QUESTION 110.1

SSES-FSAR

FSAR FIGURE 110.41-3

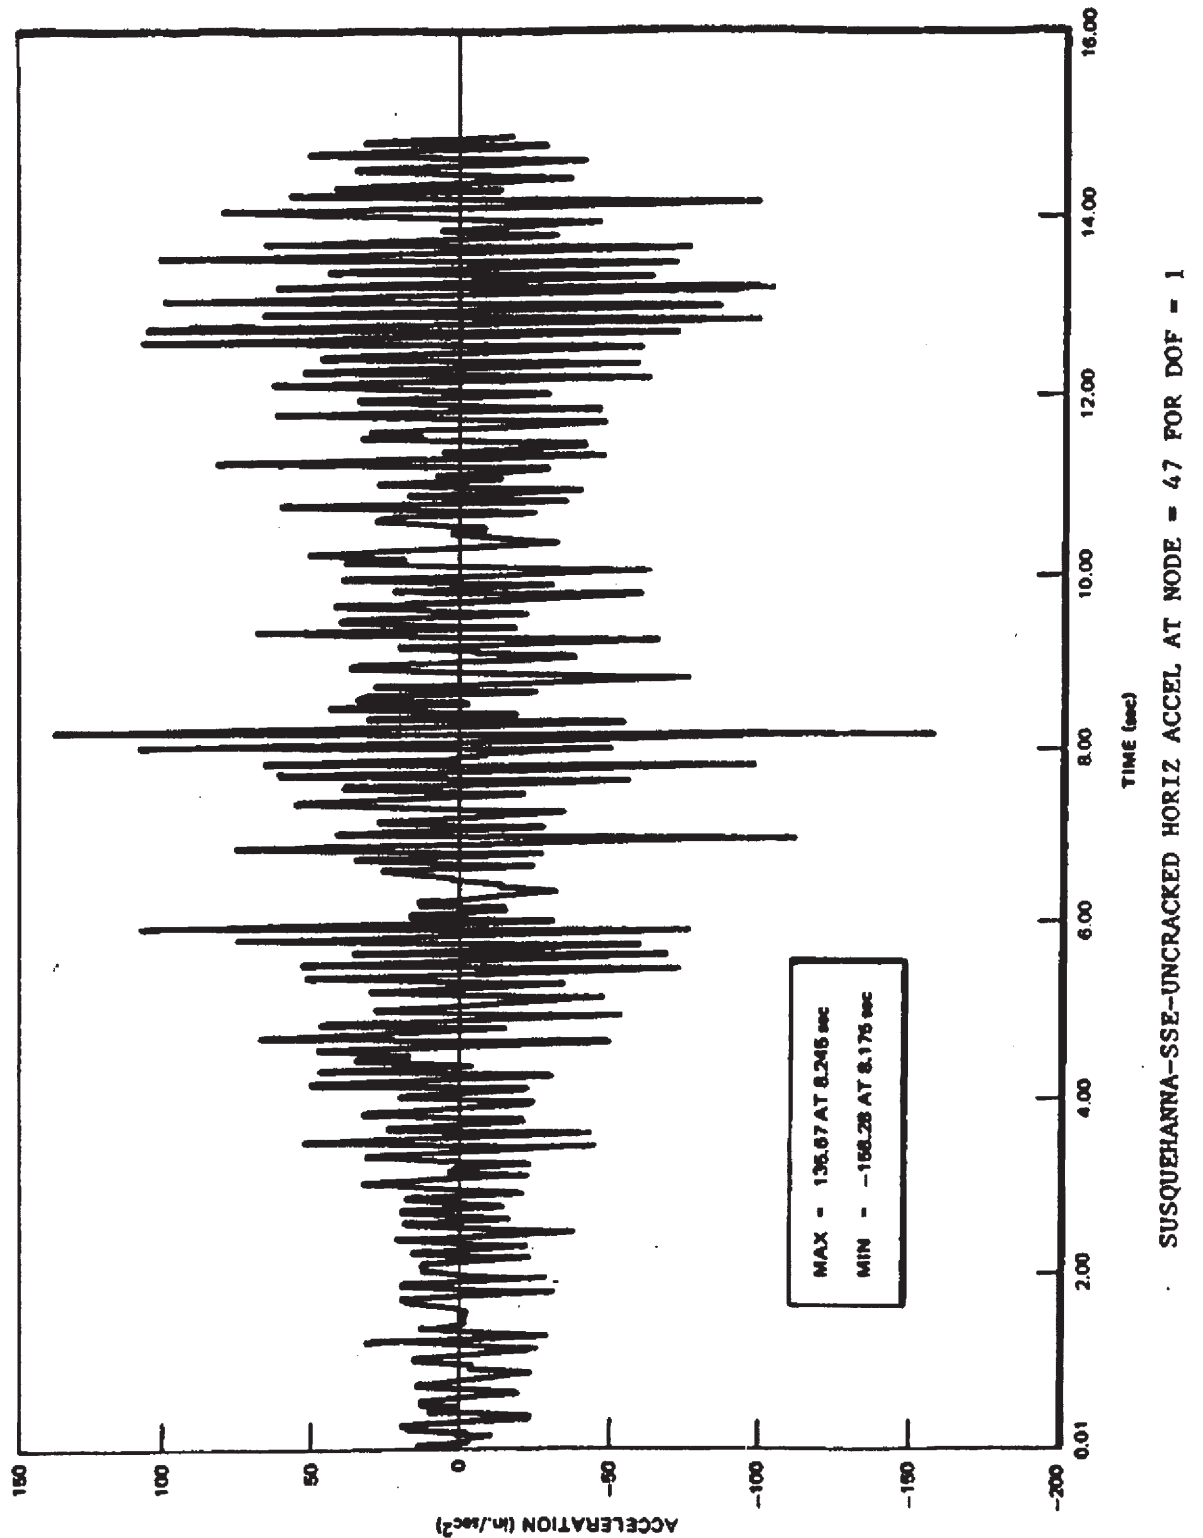
- a) Provide response time histories at one key location (having either the maximum stress combination or the most critical deflection combination, whichever is governing the design) for each of the following internal components:
 - (1) Jet pump
 - (2) Shroud wall
 - (3) Shroud head
 - (4) Control rod
 - (5) Instrumentation guide tube
 - (6) Core plate

For each location, separate response time histories for the various load effects associated with the SSE and most severe pipe break event should be provided.

Figures 110.41-3 thru 110.41-10 - Response time history plots due to horizontal SSE.
